SUBJECT: ET 26 NEXS Docking Switch Wiring Modification

SERVICE BULLETIN REF. 06/0102

DATE: January 2006

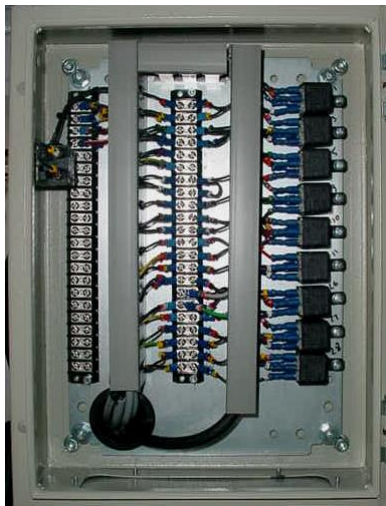
We have discovered a problem with the ET 26 & 30 NEXS machines out in the field; an operator has found that you can defeat the PTO/HANDBRAKE interlock. To overcome this problem minor a wiring change is required on all machines in service.

The wiring change is as follows: - using wiring diagram n°s see note below.
 1. The normally open wire of the docking switch (core n° 1) VDL terminal strip n° 5 found in the pedestal junction box see photograph below

Remove terminal wire n° 5 on the left hand side of the terminal strip and check for voltage using a voltmeter, the wire to be moved is the one **without voltage** on it when checked with the voltmeter, the wire n° 5 that has voltage on it needs to be refitted to terminal position n° 5. When you have correctly identified the wire coming from the docking switch (core n° 1) renumber this to terminal n° 4 and fit the wire to position n° 4 of the terminal strip
